UNITED STATES PATENT AND TRADEMARK OFFICE

APPLICATION NO.	FILING DATE	FIRST NAMED INVENTOR	ATTORNEY DOCKET NO.	CONFIRMATION NO.
10/728,901	12/08/2003	Mitsushi Ikeda	04329.3193	9313

Response to Amendment

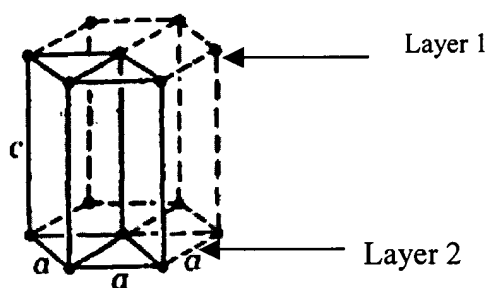
Regarding claim 1, Ikeda disclose a flat panel x-ray detector (figure 2) which comprises:

an X-ray-charge conversion film converting incident X-rays into electric charges (Figure 2, elements 208-211);

and a pair of electrodes (elements 212 and 103) disposed in contact with both surfaces of said X-ray-charge conversion film (see figure 2, where 212 and 103 are disposed on opposite ends of the conversion film);

wherein said X-ray-charge conversion film has a laminate structure (Figure 2, elements 208-211) including a plurality of metal halide films laminated (Claim 1, column 12, line 66- column 13, line 2) and differing in band gap from one another or differing in resistivity (Claim 1, column 12, line 66- column 13, line 2, materials of different resistivity inherently have different bandgaps), and halogen atoms contained in said plurality of metal halide films are of the same kind among them (column 10, lines 1-3). Ikeda discloses that the laminated materials are hexagonal structured elements such as PbI_2 (column 12, lines 24-26), but does not explicitly state that they are laminated in the direction of the c-axis. However, it is inherent that the layers of a hexagonal structure must be laminated within the c-axis because there are no other planes in which the layering could occur.
